CITY OF TONTITOWN PLANNING OFFICE

Meeting: **March 26, 2019**
Project: **Siena Townhomes 2**
Planner: Courtney McNair

i. **CONDITIONAL USE PERMIT REQUEST**

ii. **PRELIMINARY LARGE SCALE DEVELOPMENT PLAN APPROVAL**

LSD PLAN

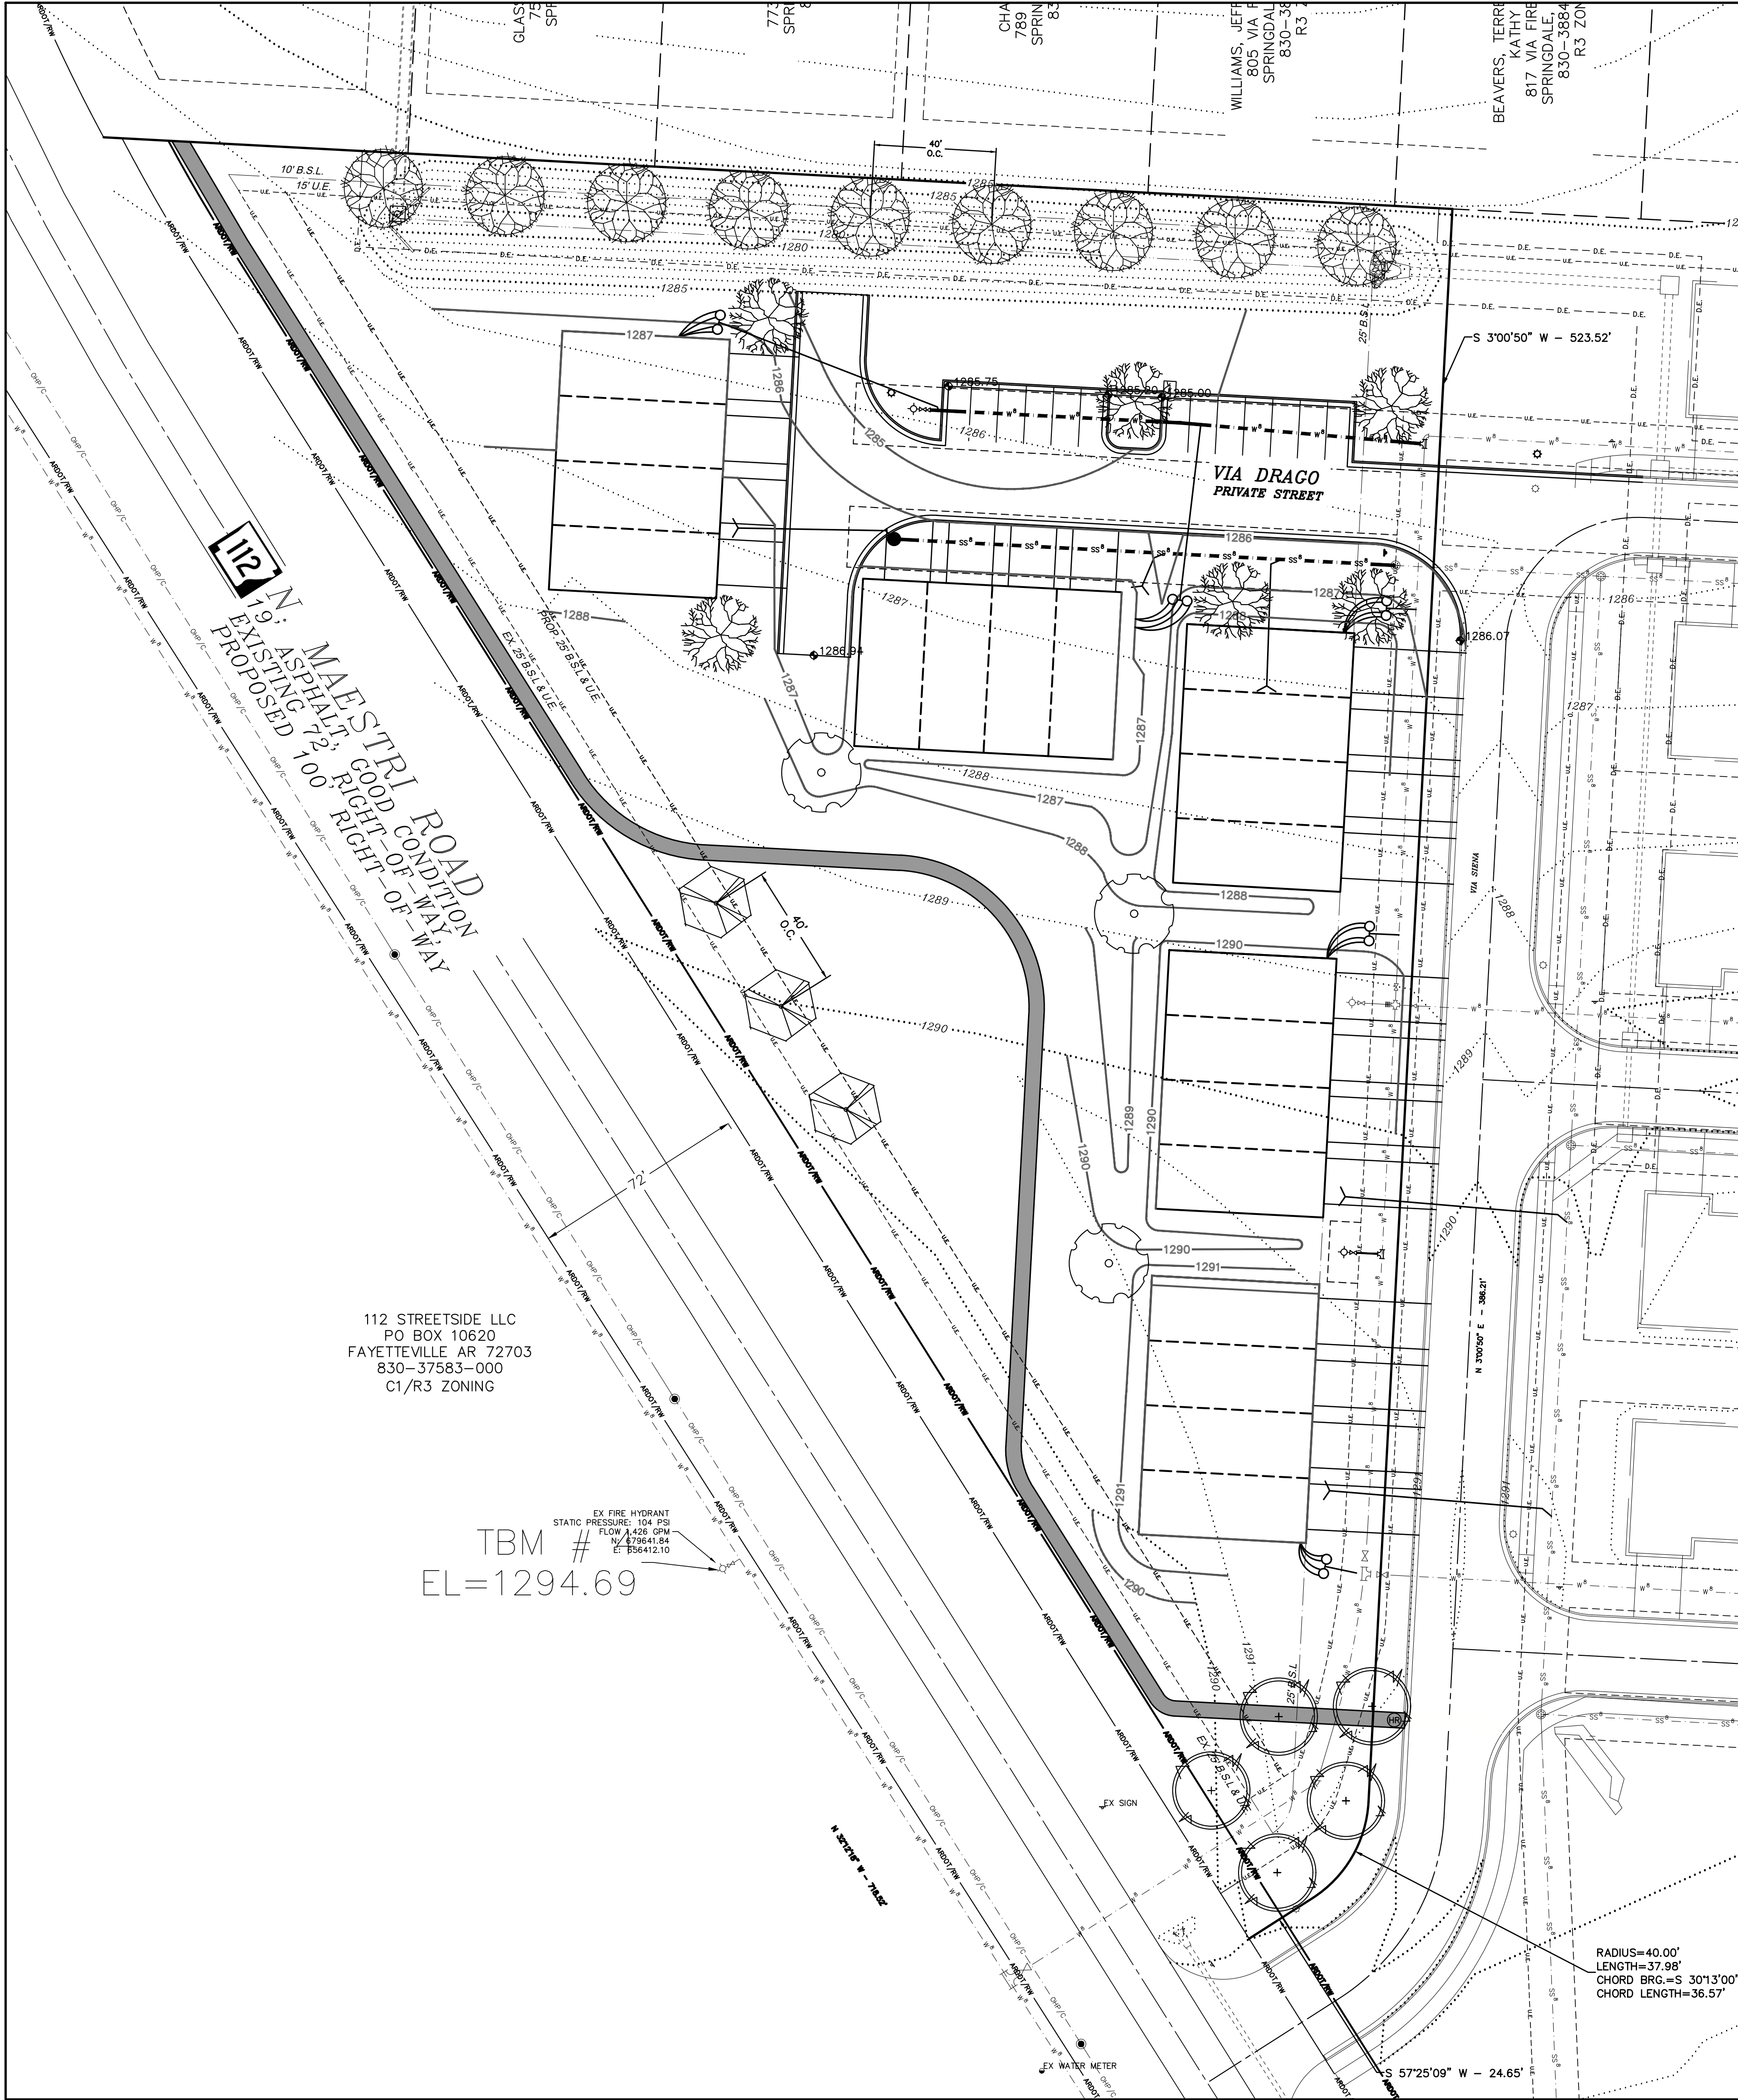
The amount of greenspace shown on the concept plan appears adequate, although some of the plantings may need to be relocated out of the utility easements. The applicant is placing evergreens along the north line between the proposed project and the existing single-family residential development.

Via Siena is 30 feet wide, the extension of Via Drago will meet the existing road width of 24-feet, and there is a 20' wide, fire-access, hammerhead proposed. All turns have the required radius for fire apparatus access. Fire Lane striping is shown on the plans. All interior drives must meet the required compaction rating to support emergency vehicles.

The applicant is showing a 5-foot sidewalk along N. Maestri that meanders into the site. This must be increased to 6-feet in width to be in compliance with the Master Street Plan. Additionally, staff is not concerned overall with this placement, but will require that it continue along N. Maestri at the south of the site. Currently it is shown to turn to give access to the existing play area in Siena Townhomes Phase 1, but will also need to provide connection south along N. Maestri.

7. The sidewalk along N. Maestri shall be increased to 6-feet in width to be in compliance with the Master Street Plan.
8. The sidewalk shall continue along N. Maestri at the south of the site to provide connectivity to the south.

A3.1

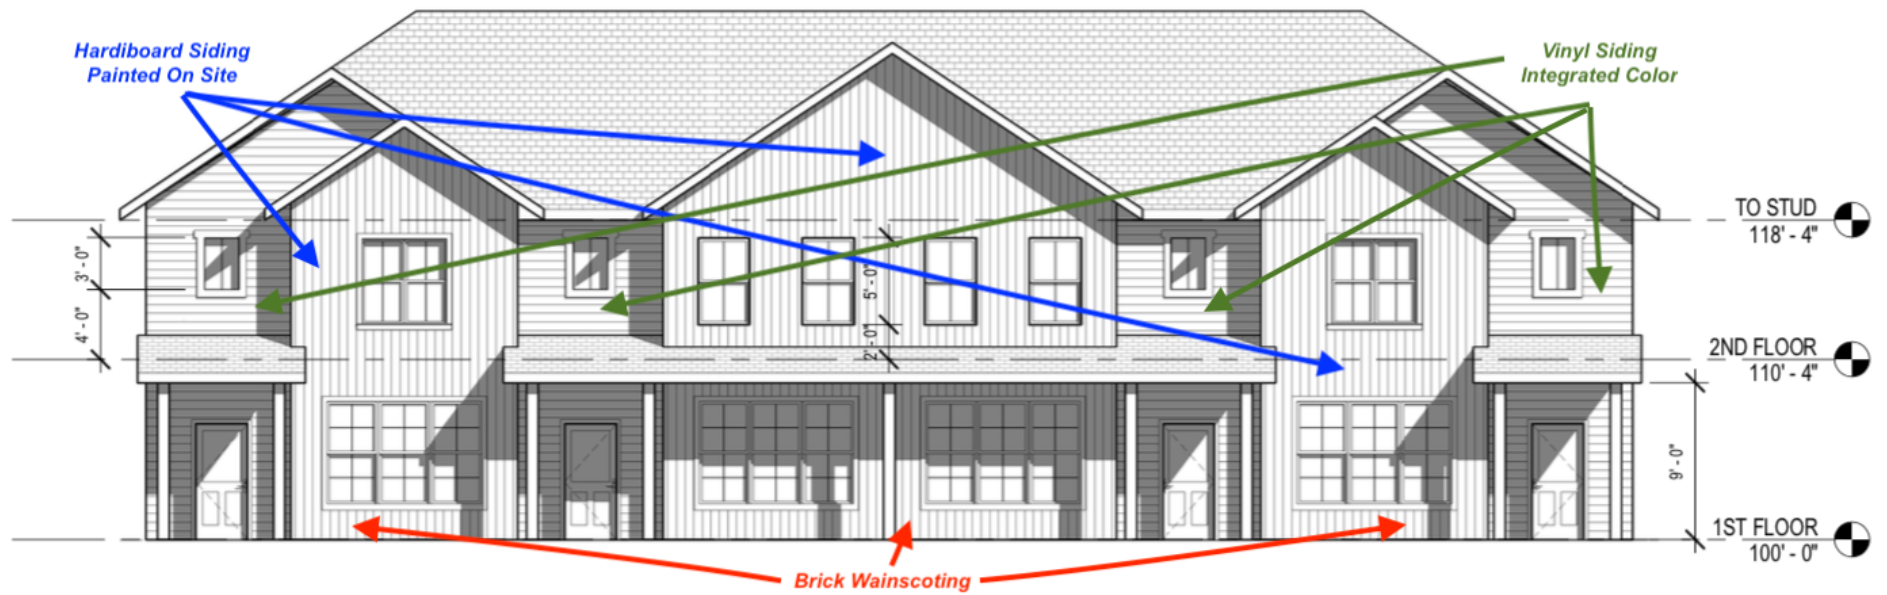
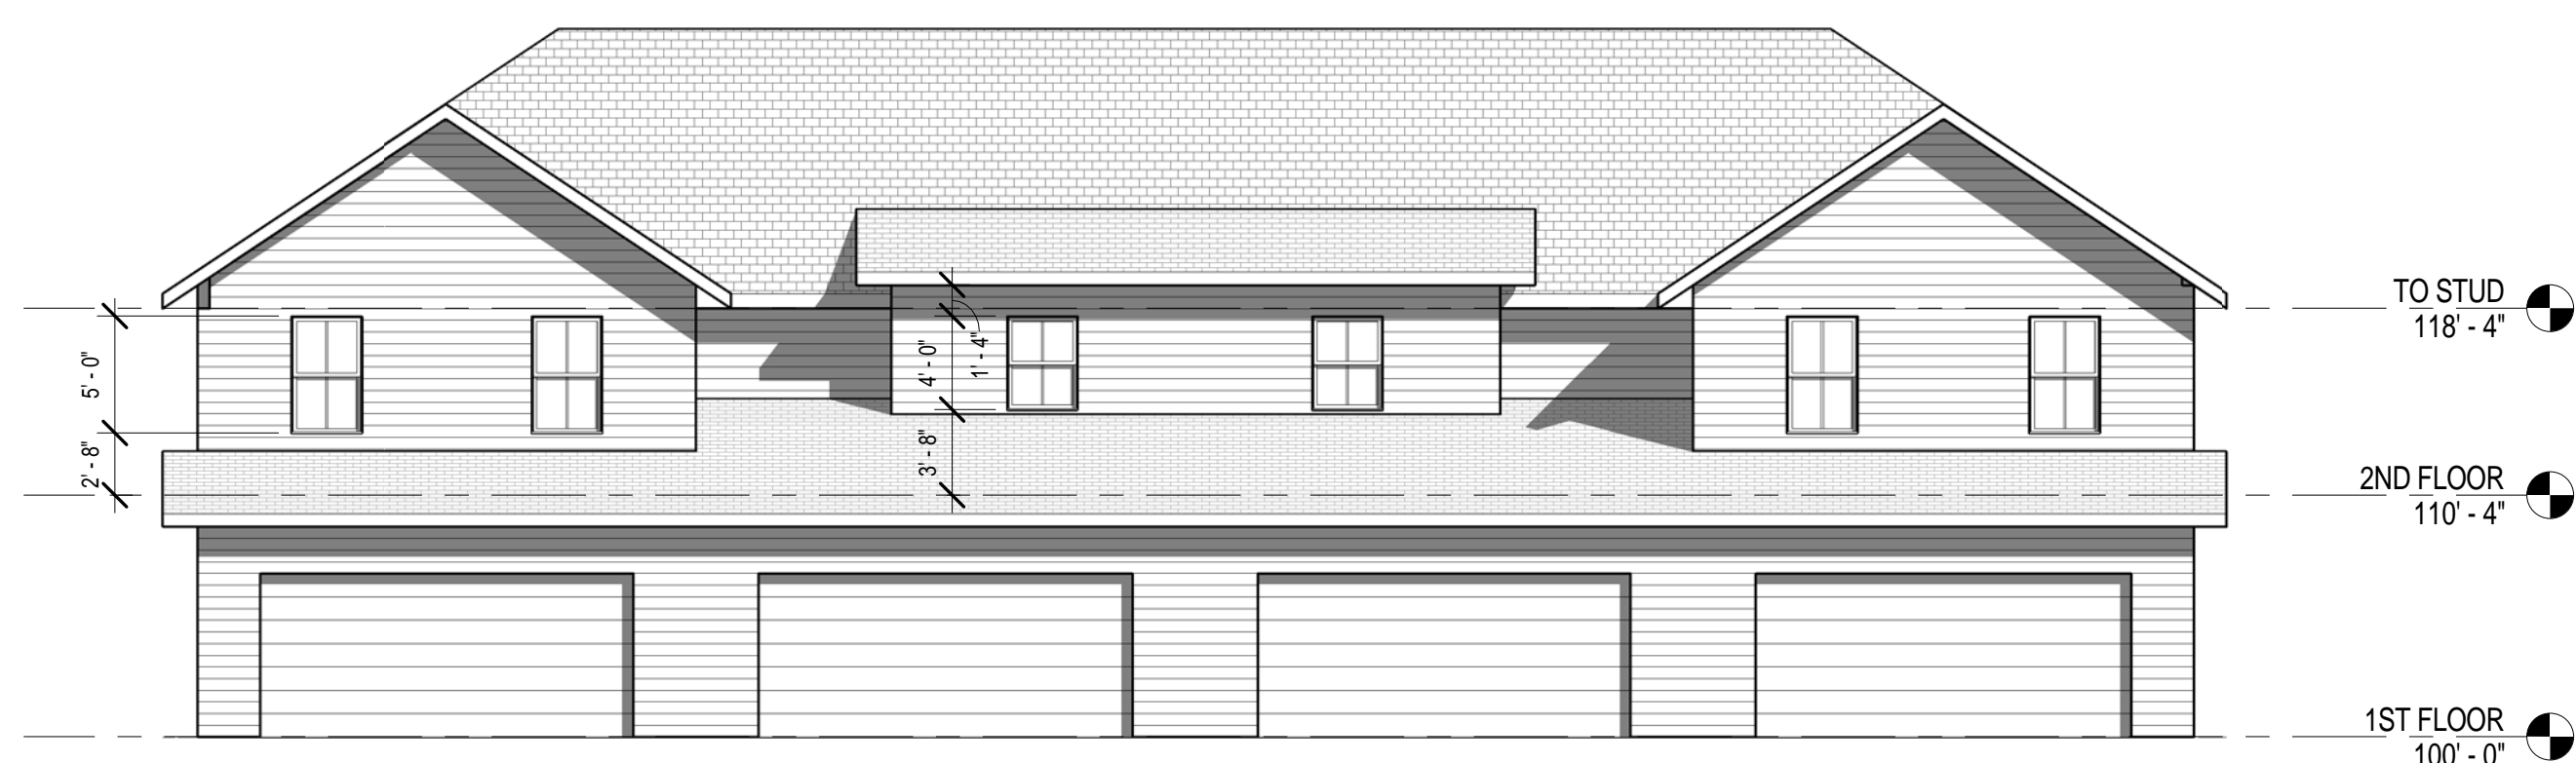
Architectural elevations were submitted. The plans submitted do appear to meet the architectural standards for Large-Scale Development projects. All facades facing N. Maestri shall be in compliance with these standards.

9. All facades facing N. Maestri shall be in compliance with the Large-Scale Development Architectural Standards.
10. Some of the plantings may need to be relocated out of the utility easements.
